No. EC120-25A031

ALERT SERVICE BULLETIN

**EQUIPMENT AND FURNISHINGS - Emergency Floatation Gear
New Emergency Floatation System (EFS) "FLOAT ARM"
push-button location**

Revision No.	Date of issue
Revision 0	2023-10-25

Figure 5

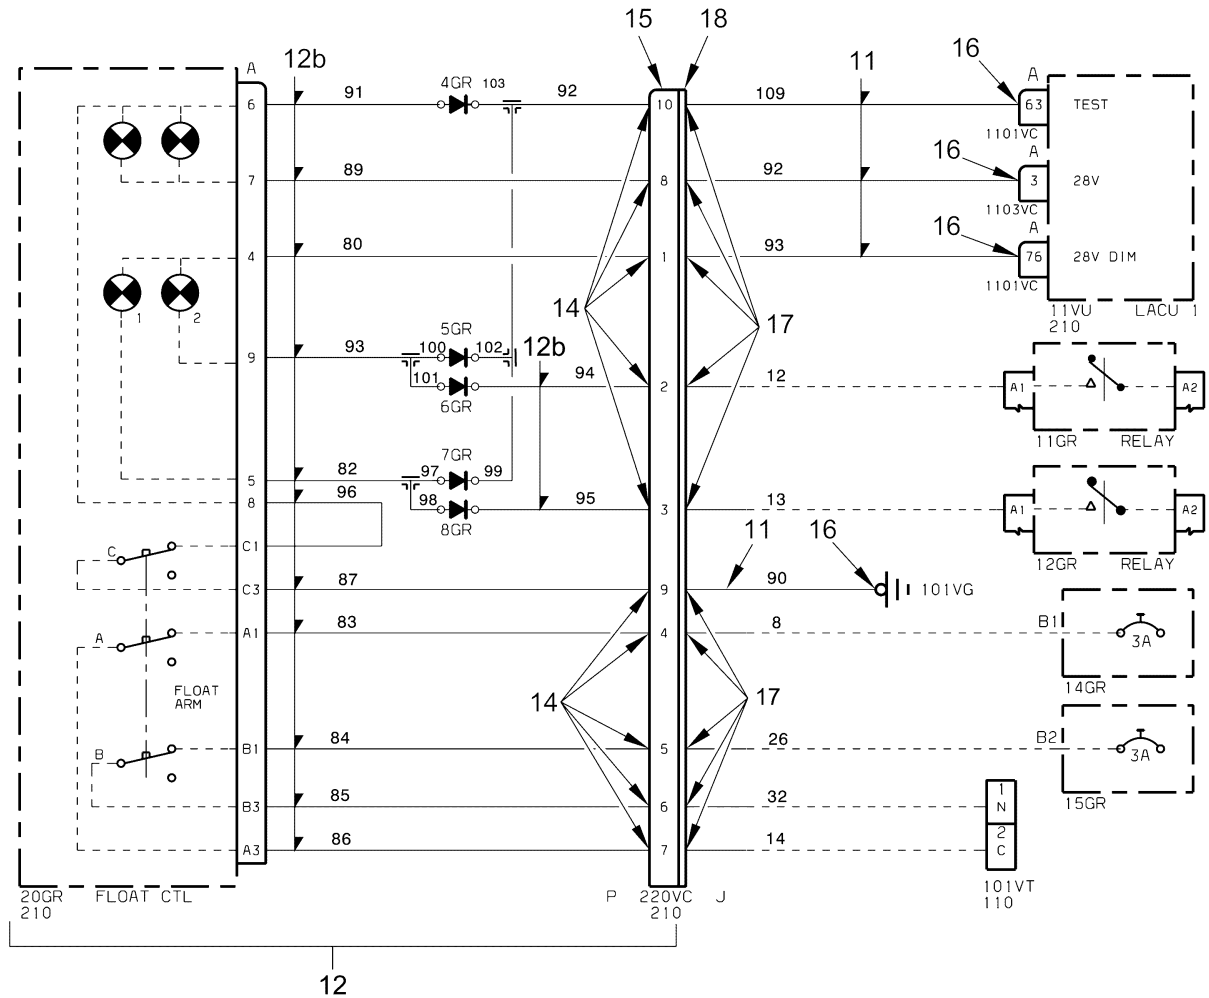
3.B.2.c. Modification of the electrical wiring ([Figure 3](#), [Figure 4](#) and [Figure 5](#))

- Cut to the required length and connect the wire (12b) with ([Figure 4](#) and [Figure 5](#)):
 - . The contacts (14)
 - . The module (15).
- Modify the electrical wiring with:
 - . The wires "2567-0109", "2567-0092", "2567-0093" and "2567-0090" from the set of wires and labels (11)
 - . The contacts (16) and (17)
 - . The module (18).
- Do a continuity test on the installed wires.

Figure 6

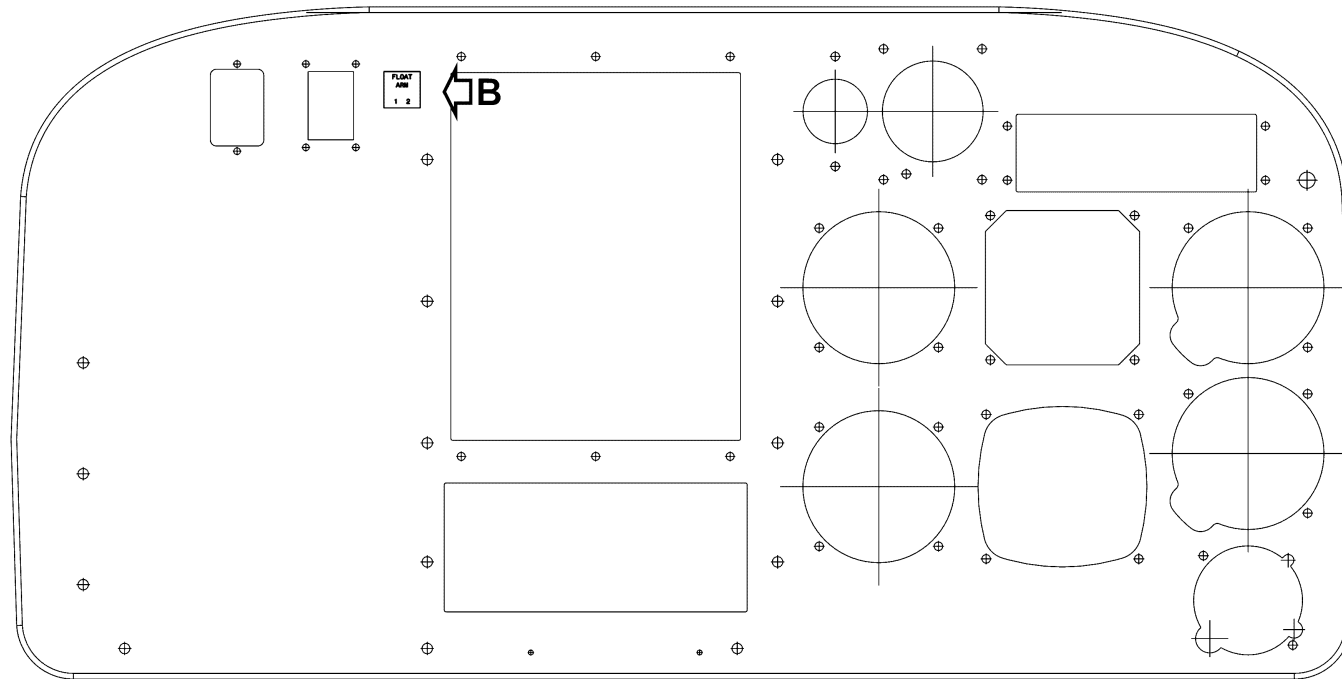
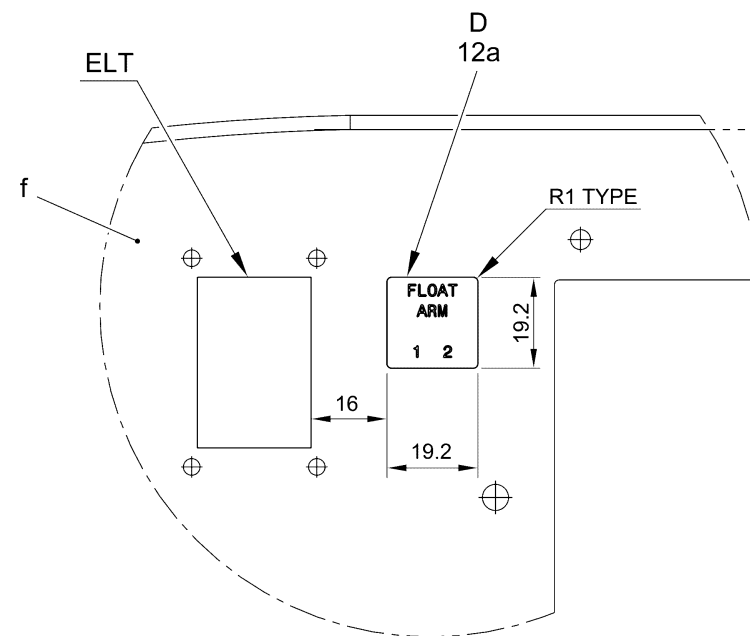
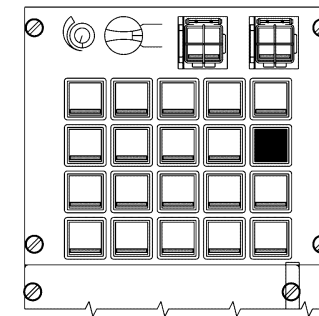
3.B.2.b.3. Modification of the push-button location on the instrument panel - **CONFIGURATION 3** ([Figure 3](#) and [Figure 6](#))

- Do the cut-out (D) and deburr in accordance with the dimensions ([Figure 6](#), Detail B).
- Install the push-button (12a) of the ramp (12) on the instrument panel (f).
- Bond the label "20GR" from the set of wires and labels (11) as near as possible to the push-button (12a) on the back of the instrument panel (f) (not shown).
- Drill the holes (C) in accordance with the dimensions to a diameter of 3.3 mm ([Figure 3](#), Detail D).
- Deburr the holes (C) and clean the work area.

Figure 7

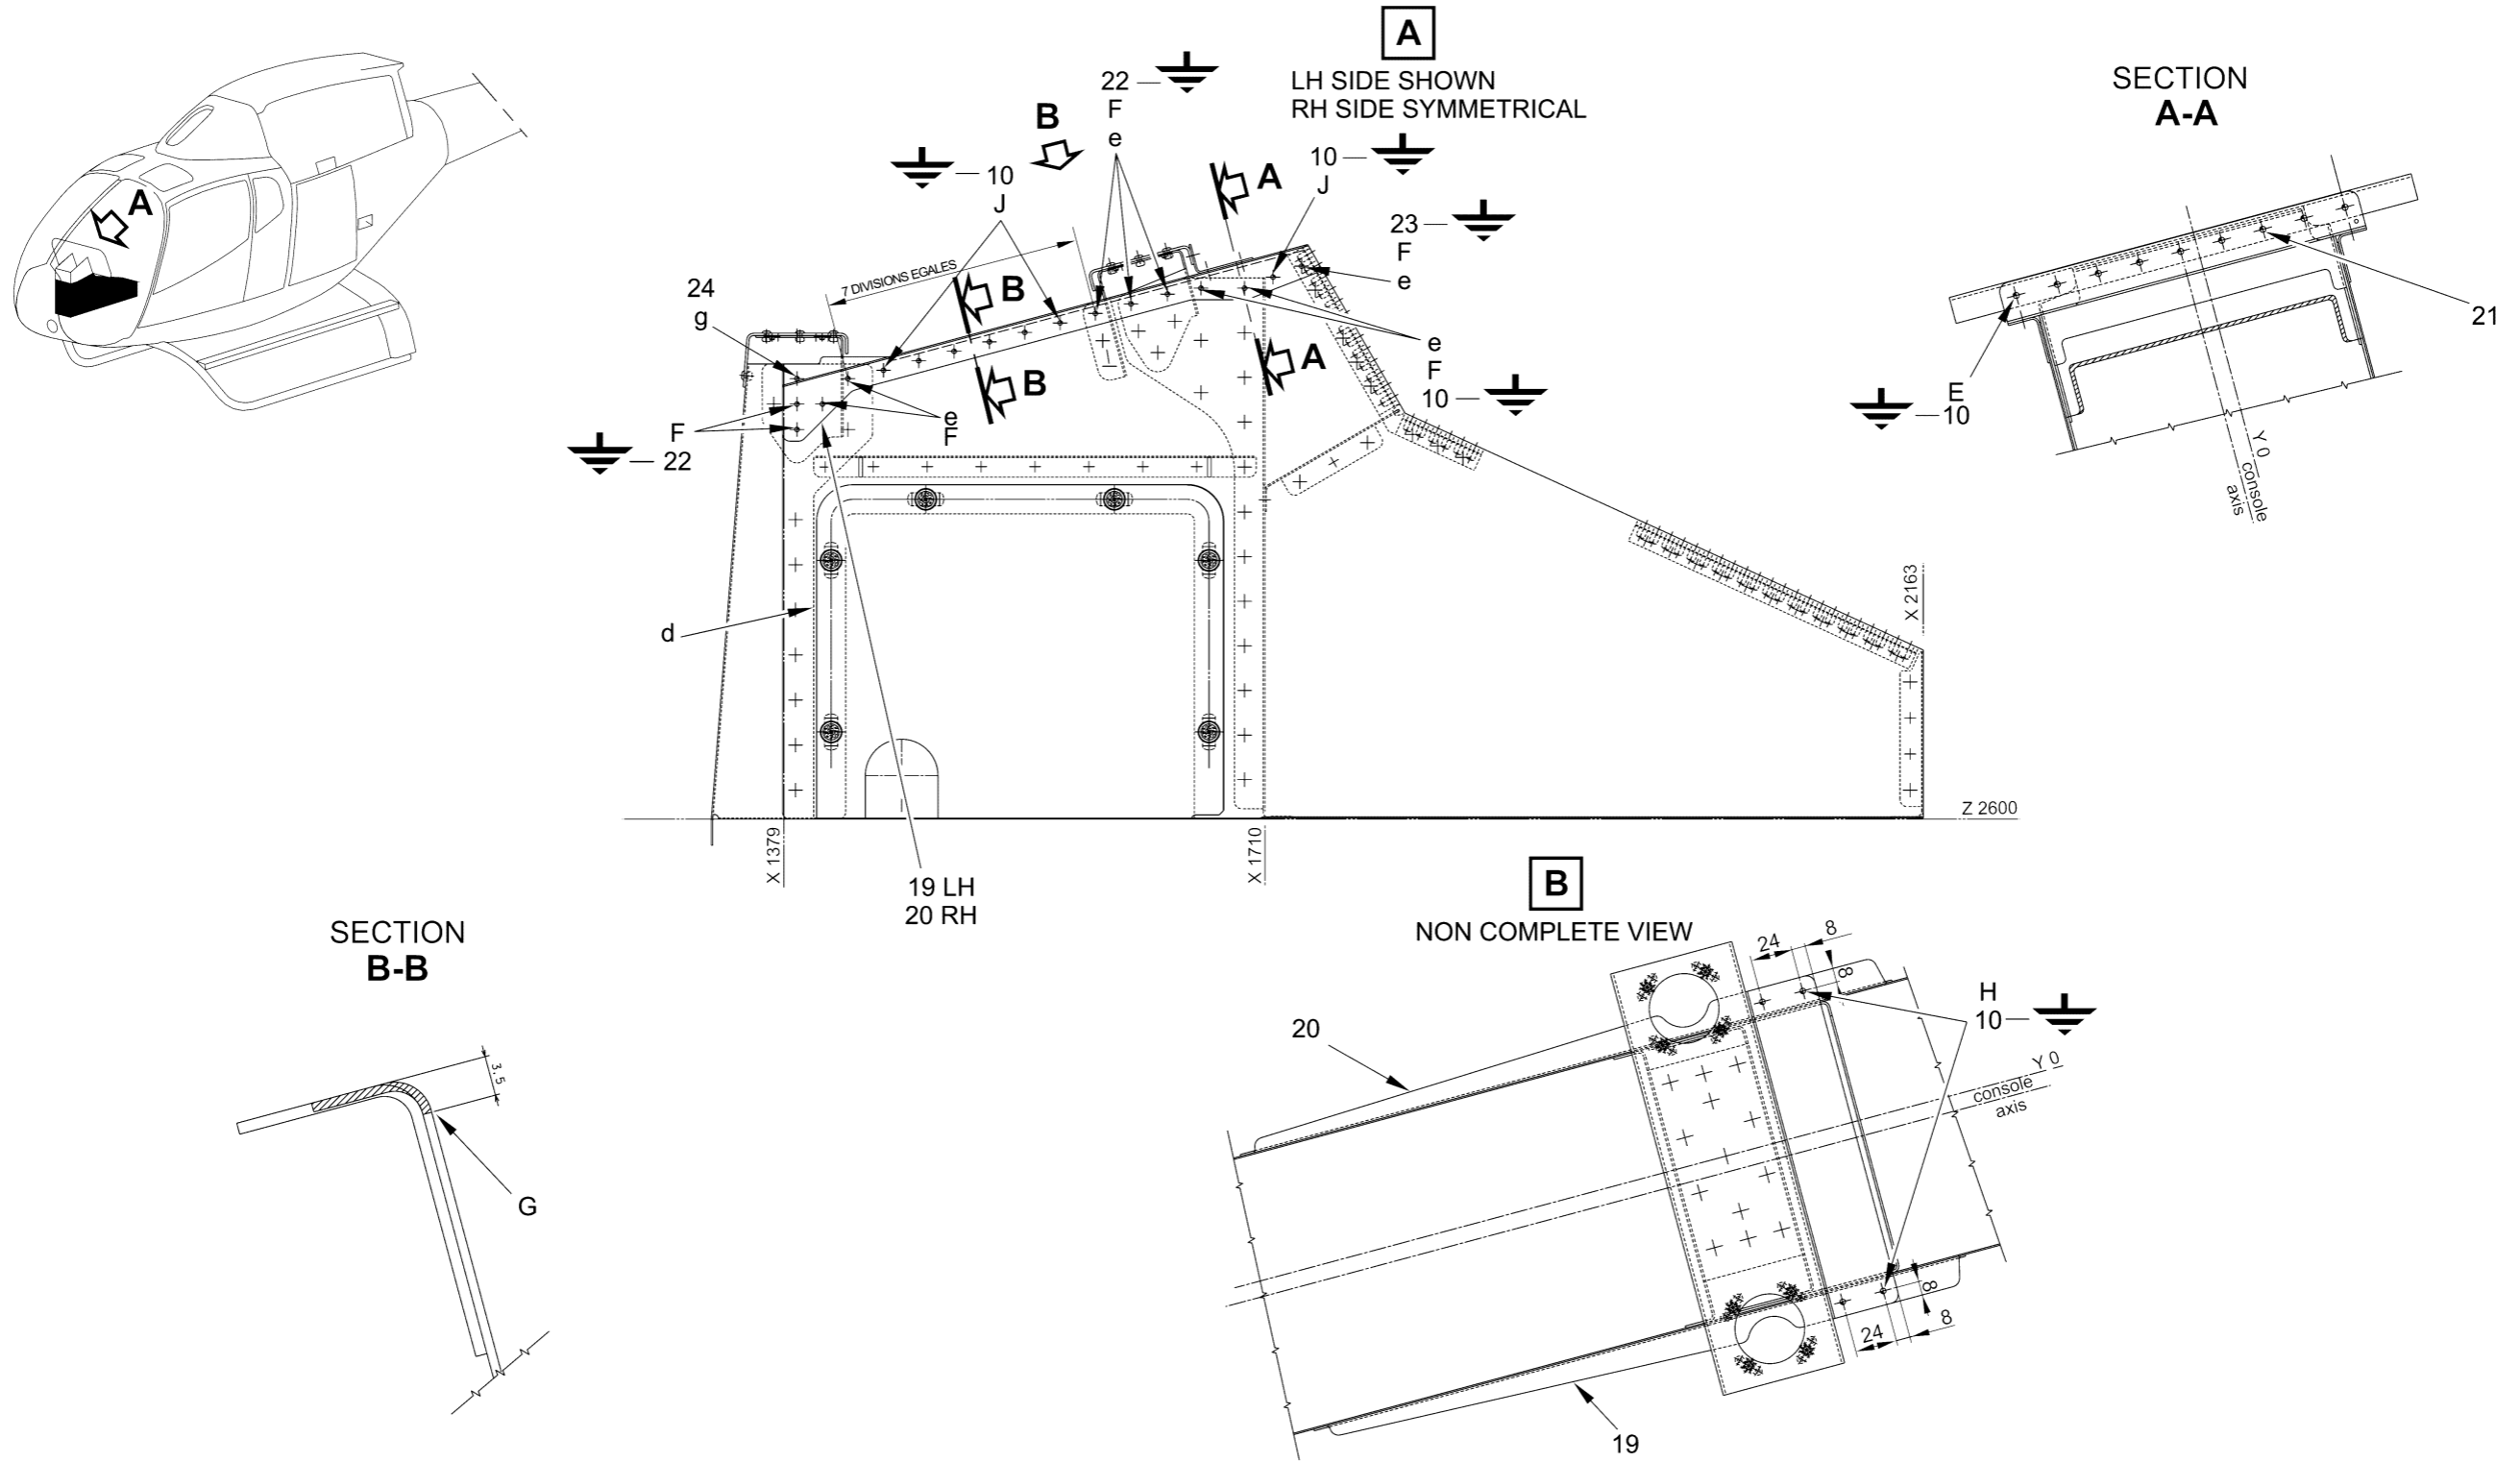
3.B.2.b.2. Modification of the push-button location under the instrument panel - **CONFIGURATION 2** ([Figure 2](#), [Figure 3](#) and [Figure 7](#))

- Remove the rivets (c) ([Figure 2](#), SECTION A-A).
- Remove the rivets (e) ([Figure 7](#), Detail A).

Only the LH side is given. Do the same procedure for the RH side with the RH stiffener (20).

- Do the cut-out (G) on the console (d) in accordance with the dimensions ([Figure 7](#), SECTION B-B).
- Put in position the LH stiffener (19) to match with the console (d) (Detail A).
- Counter-drill the stiffener (19) to match the holes (F) and (J) of the console (d) to a diameter of 3.3 mm.
- Put in position the reinforcement angle (21) on the console (d) (SECTION A-A).
- Drill the holes (E) (SECTION A-A) and the holes (H) (Detail B) on the reinforcement angle (21) to a diameter of 3.3 mm.

If necessary, the rivet (g) can be replace by the rivet (24) ([Figure 7](#), Detail A).
